**CITY OF DOVER, DELAWARE
PLANNING COMMISSION
Monday, October 16, 2023 at 7:00 PM**

AGENDA

RE: **Dover Logistics Center fka Lafferty Lane Warehouse**
Site Plan Approval Extension Request
(Conditional Use) Site Plan: C-21-07 Lands of First State Business Center, LLC.
Tax Map No.: 2-05-077.00-01-28.03-00001
DBF #: 2261J024.J01

SUBJECT: S-23-18 Delaware State University New Agriculture Building

C-001

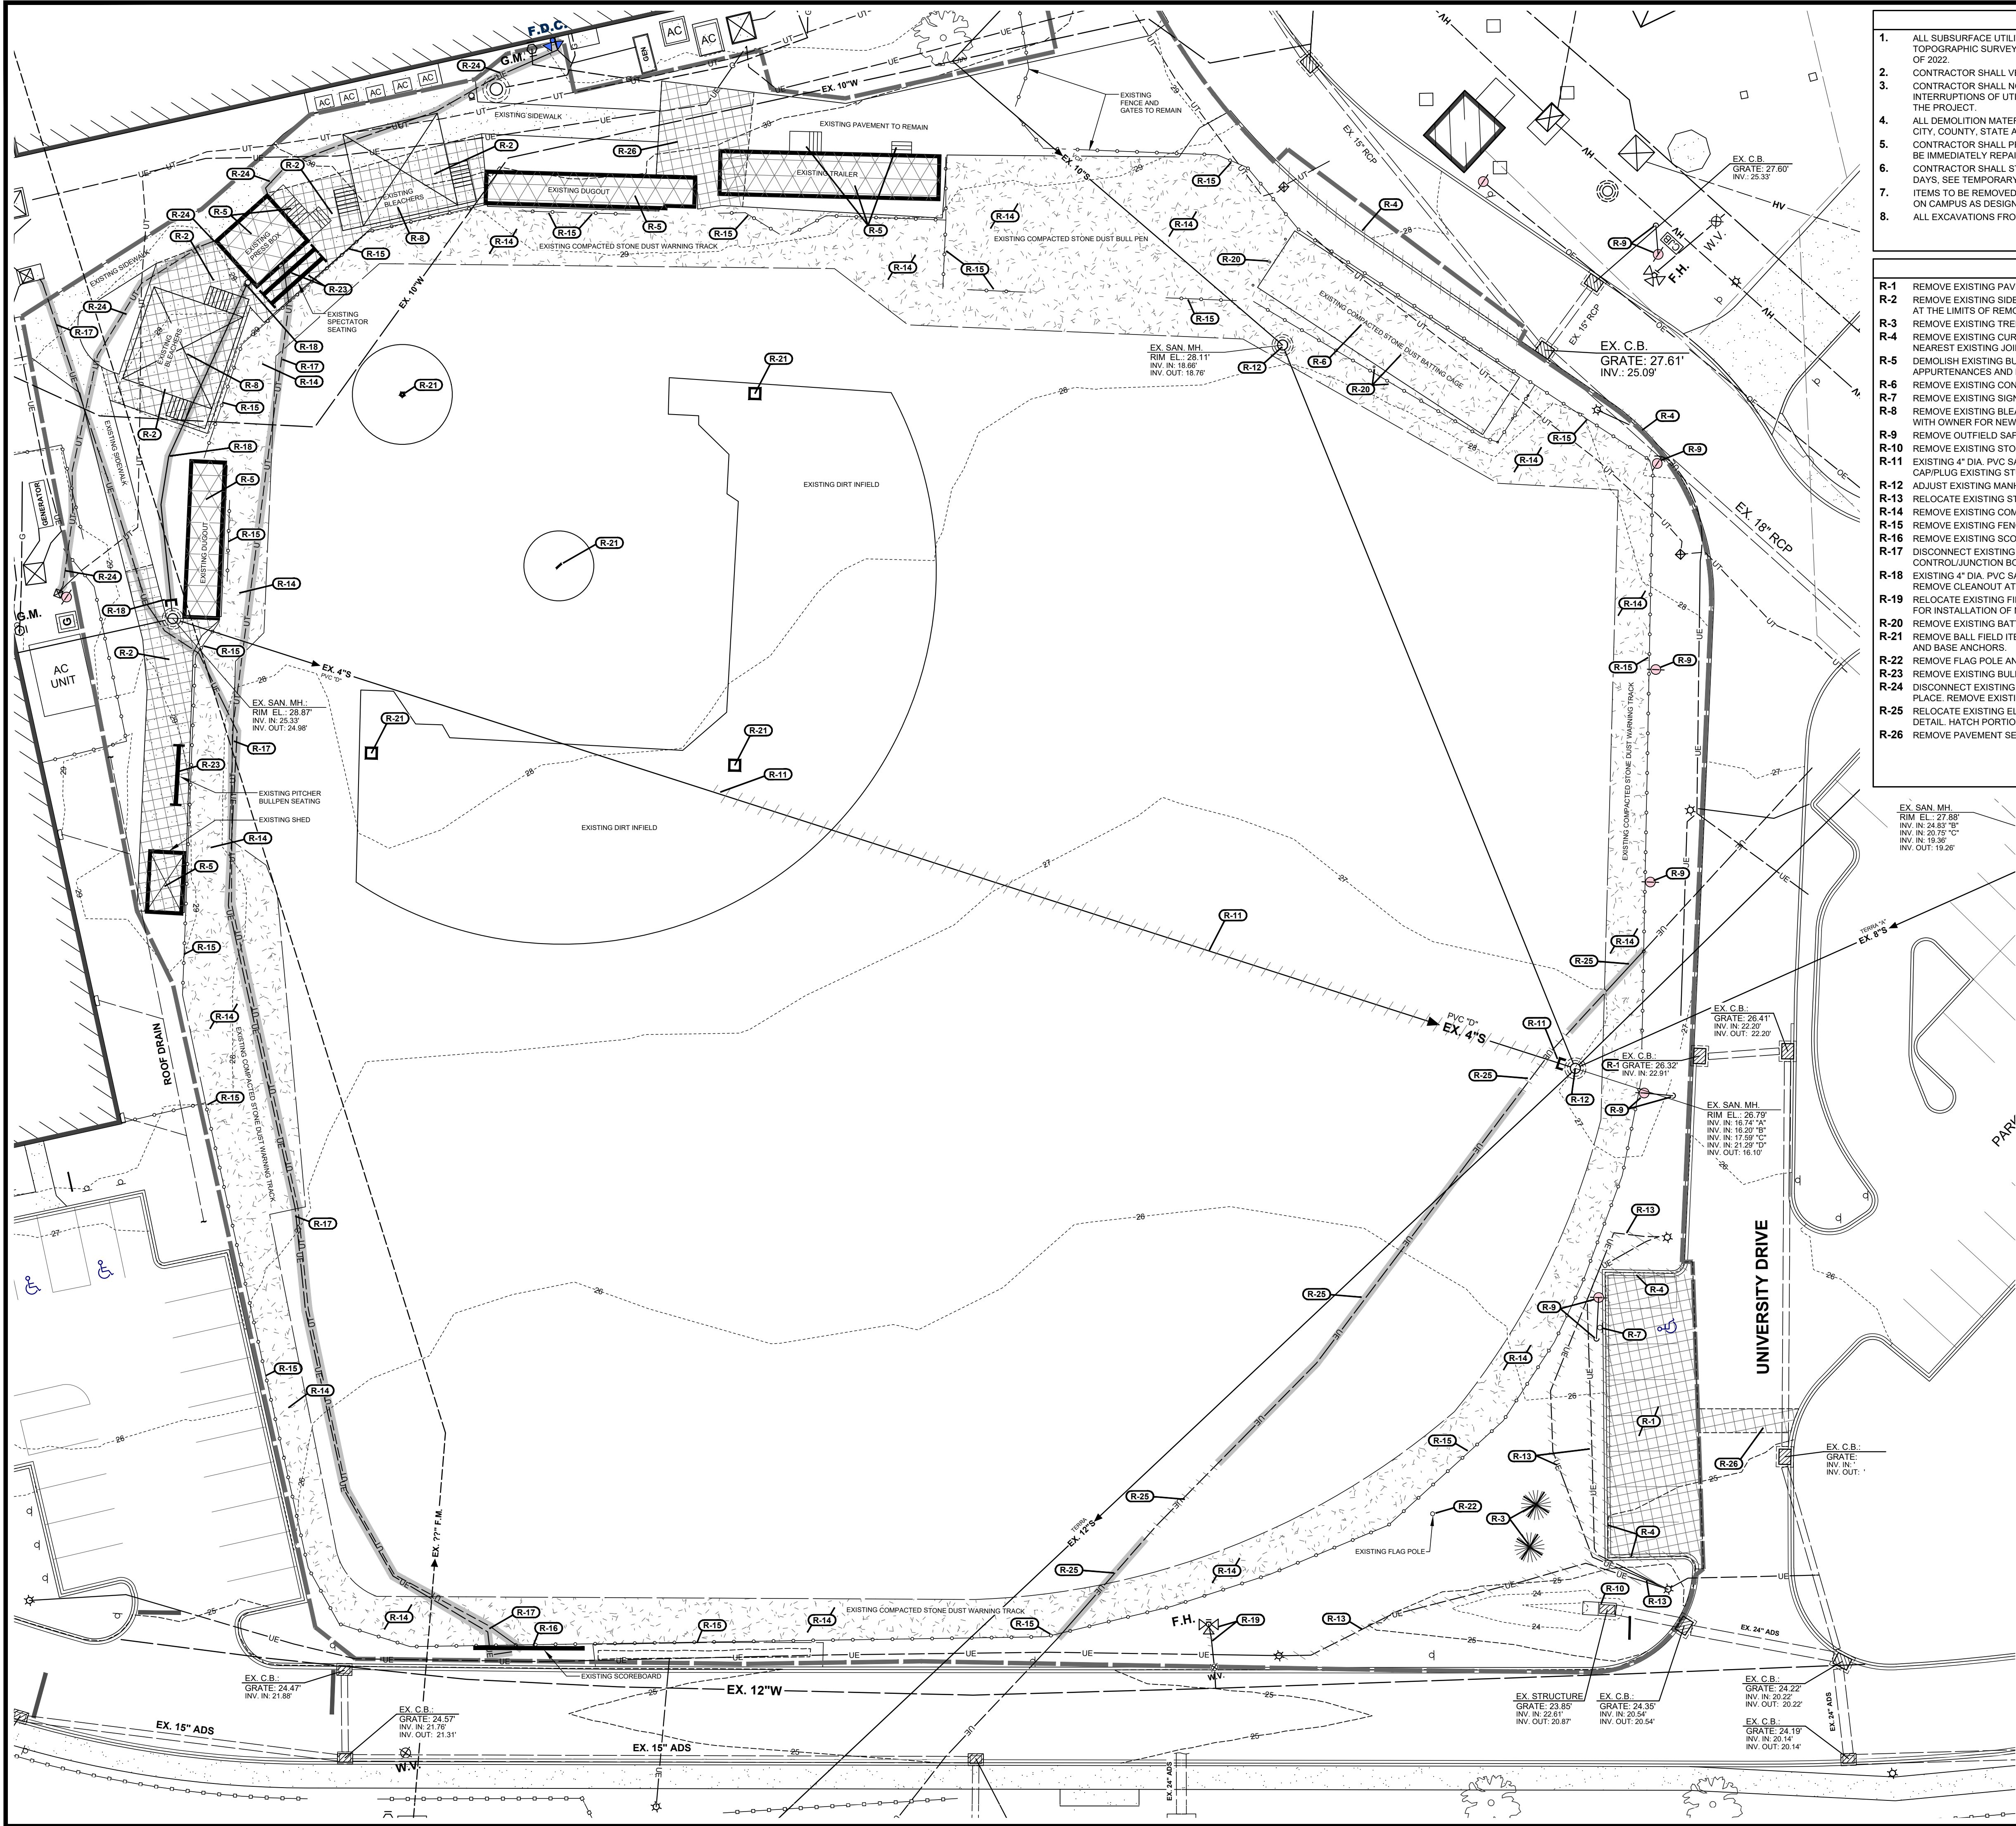
- 1) Please replace all references of Public Works to Department of Water/Wastewater.
- 2) Sheet C-001, Site Data Column:
 - a) Item 9: Confirm if the existing impervious to remain (5,986 SF) is included in the Proposed Project Site Impervious Coverage of 33,730 SF. Revise calculations if

PRELIMINARY PLAN
SITE PLAN

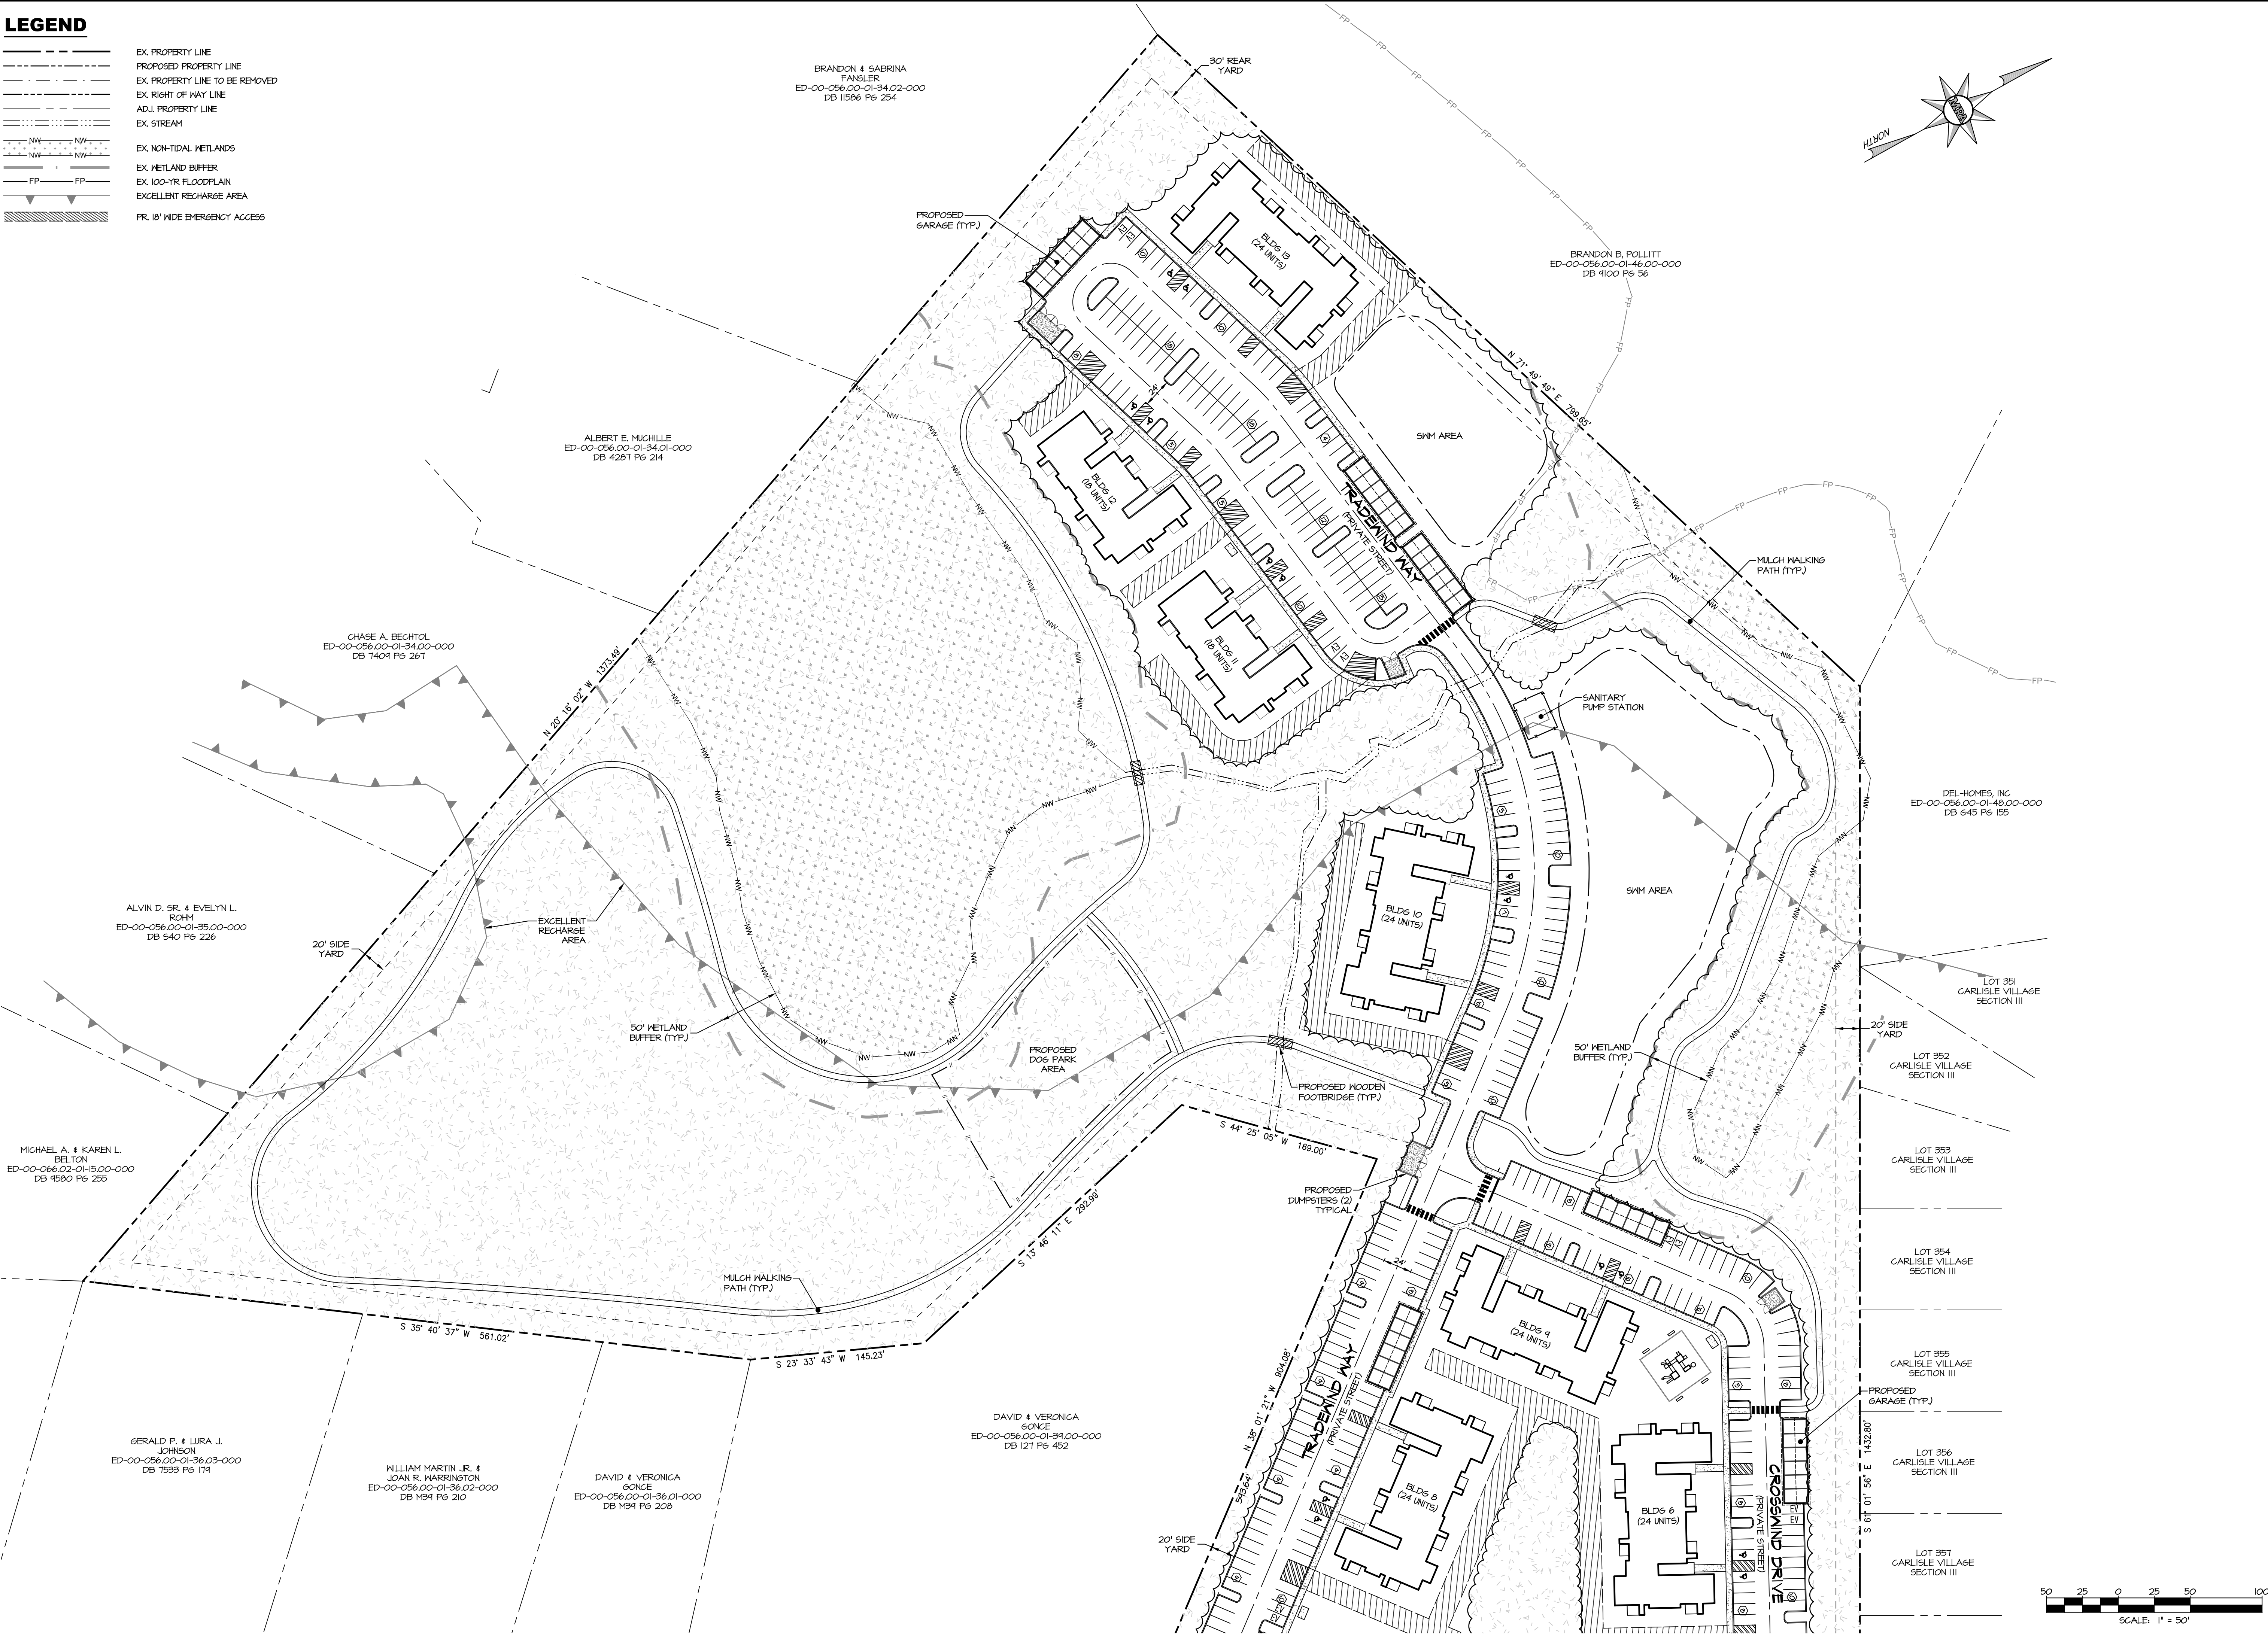
- 8) Sheets 4 and 5 - Preliminary Site Plan:
 - a. Create a distinct match line between plan sheets.
 - b. Clarify the type of curbing for parking lots and drive aisles.
